RIVERBEND CROSSING
FILING NO. 1
STREET, STORM, & STRIPING
CONSTRUCTION DRAWINGS

STREET IMPROVEMENT, STORM SEWER, AND SIGNAGE & STRIPING CONSTRUCTION DRAWINGS

PCD FILE #: SF-18-044

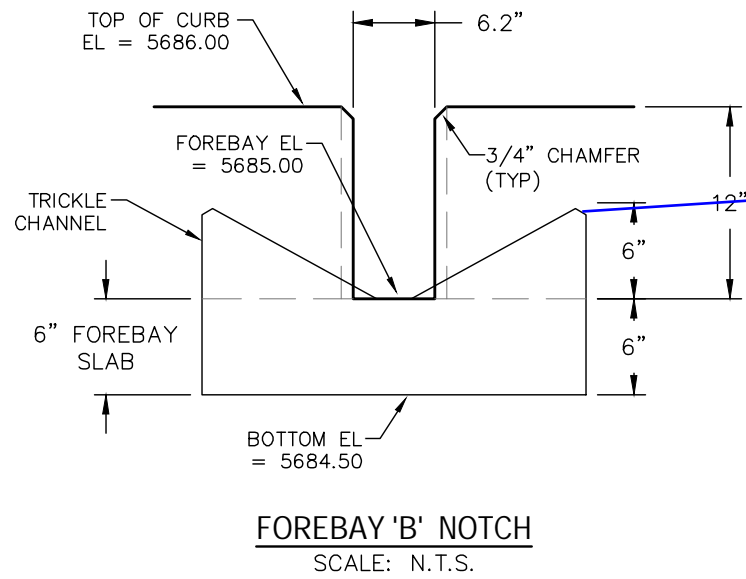
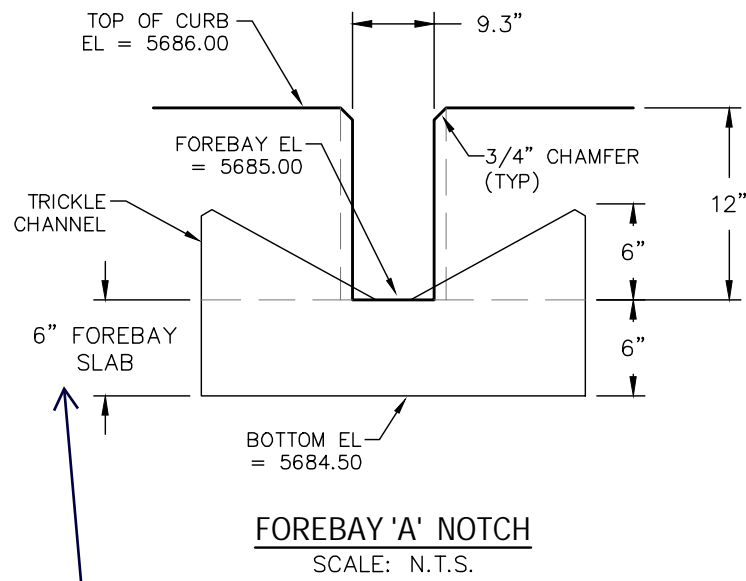
Update the forebay detail to show the finished ground relative to the forebay top of curb. Based on the Forebay notch detail, finished ground is 6" lower than top of curb. Soil riprap is required when downstream grade is lower than top of curb.

Revise the outlet structure/energy dissipator. Per UDFCD Vol 2. The baffle design provided is only appropriate for up to 48" diameter. For the larger 60" diameter conduits use the Type VI impact basin. See Figure 9-45 in UDFCD DCM Vol 2 and/or EPC DCM Vol 1 Figure 10-8a and Figure 10-8b. Provide the design calculations in the drainage report. Unresolved.

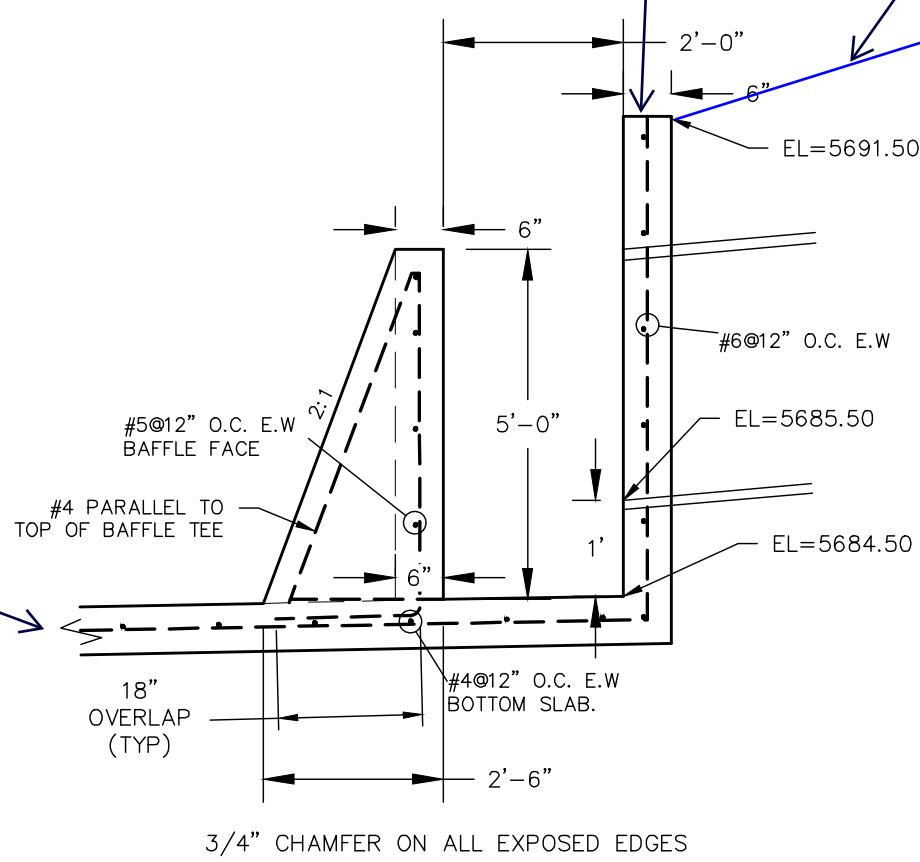
Based on height of headwall, provide a safety rail

Draw and label finished ground

Forebay "B" Baffle detail is missing.

Label width label of baffle.

Provide spot elevation along the forebay wall and forebay floor. Not enough detail provide to show the profile of the wingwalls.

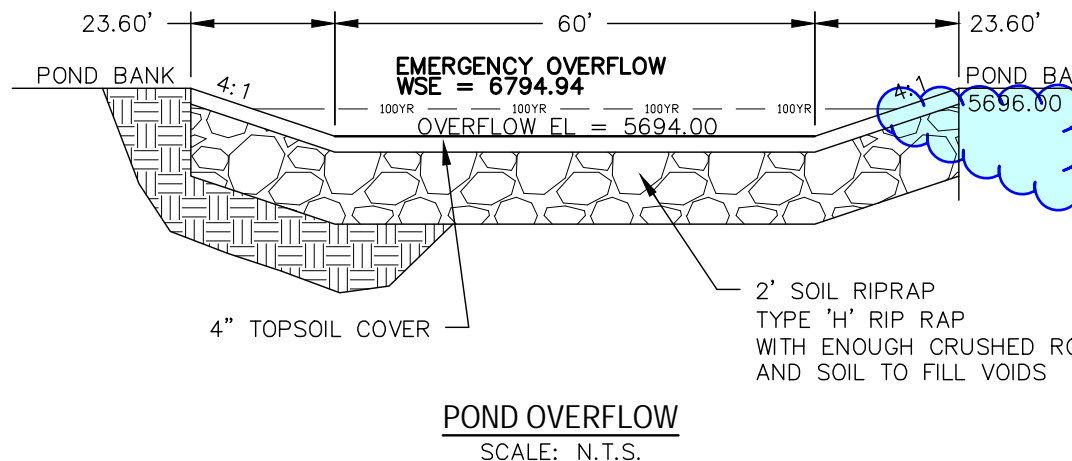
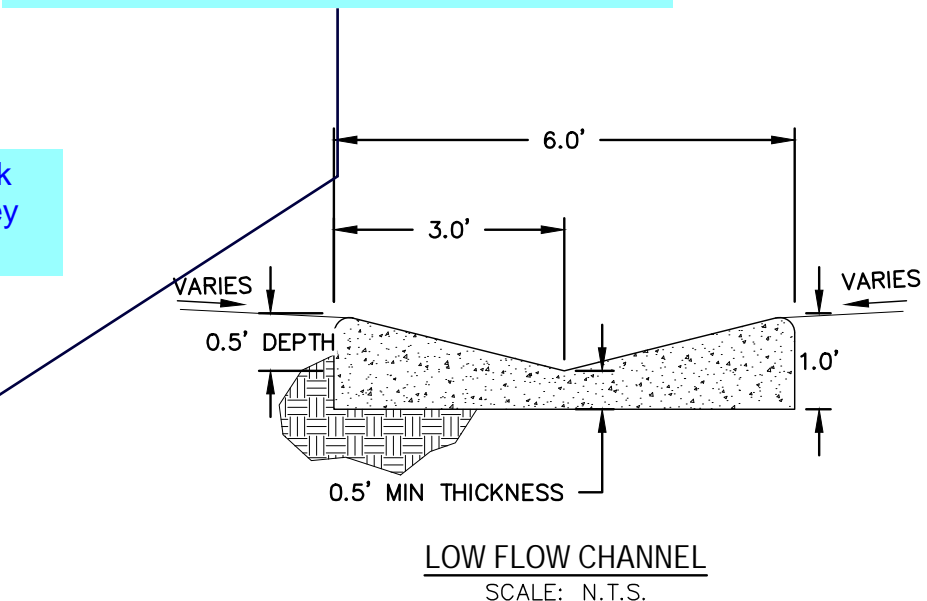
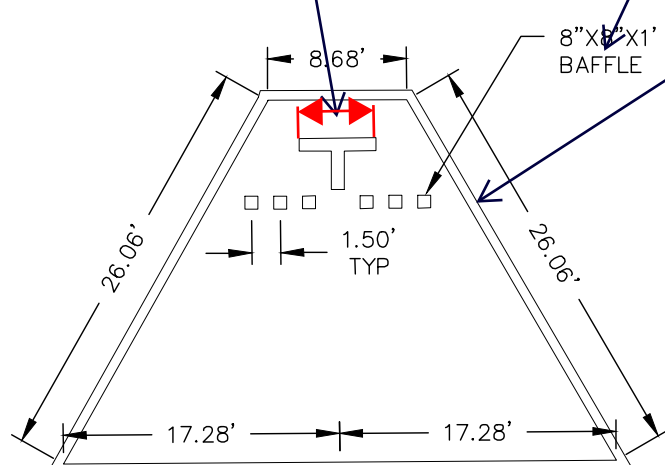
Update baffle block label to specify they are 1' high.

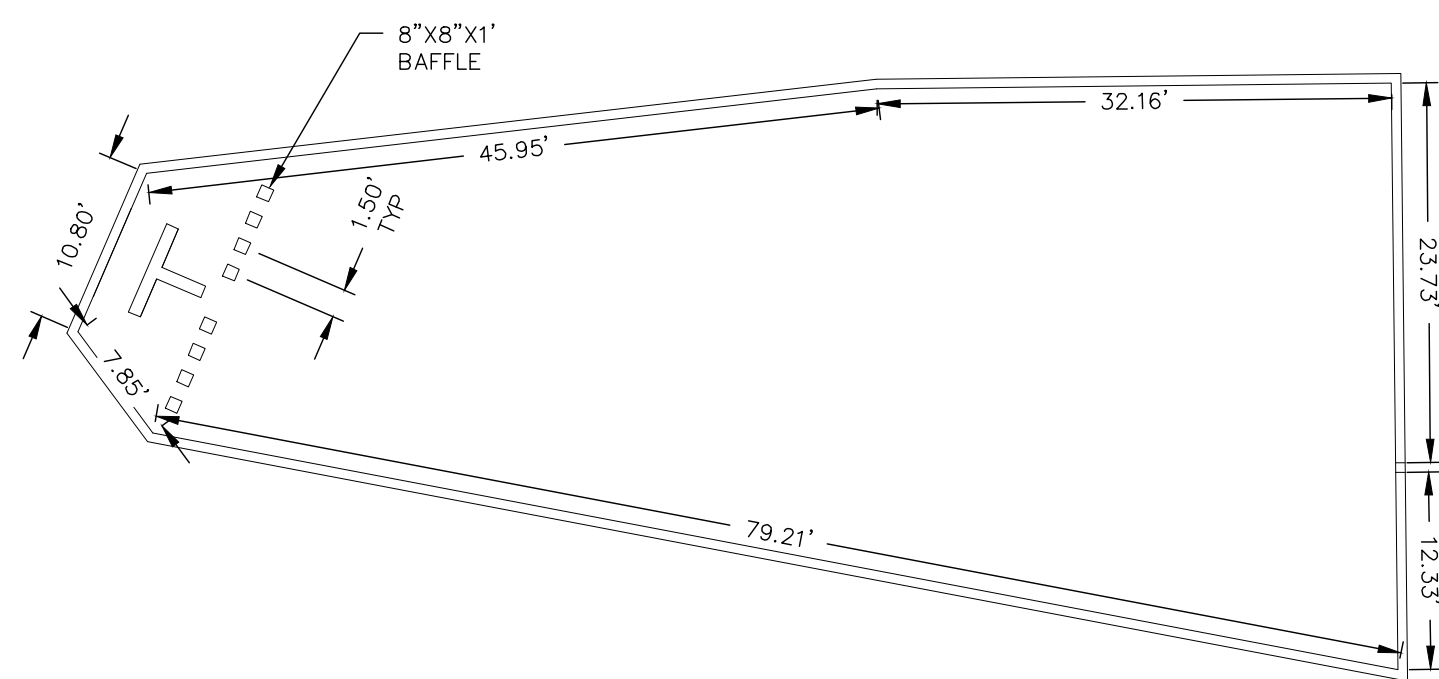
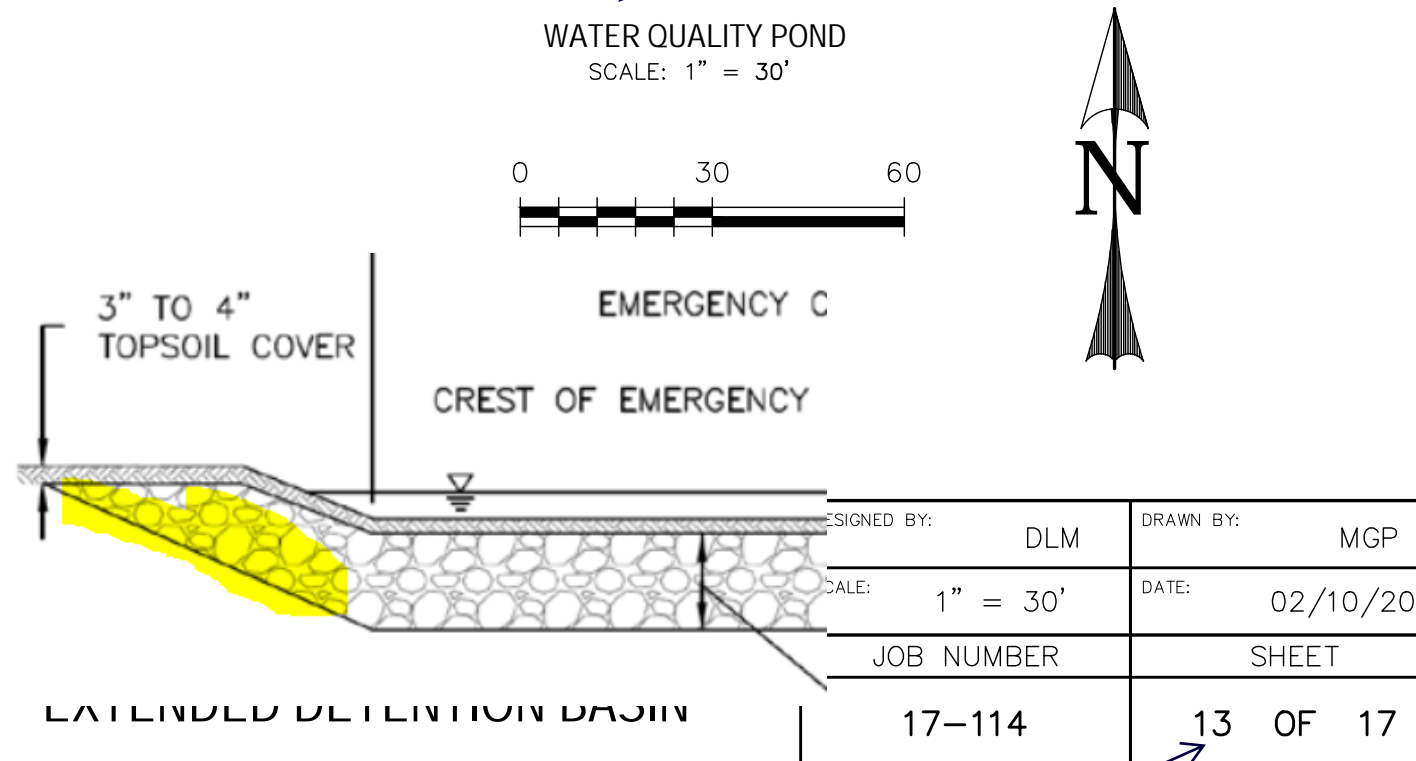
Revise to continue the 4:1 to the top of bank. Unresolved. See example to the right

Revise access ramp to 15' wide minimum @ 12% max per EPC DCM 11.2.2.

Label low channel slope. Unresolved.

Label bottom of pond slope. Slope towards the trickle channel or micropool at a 3% min. slope.

Identify as Extended Detention Basin. This pond is designed for both WQ and Detention. Unresolved.

Update Sheet number
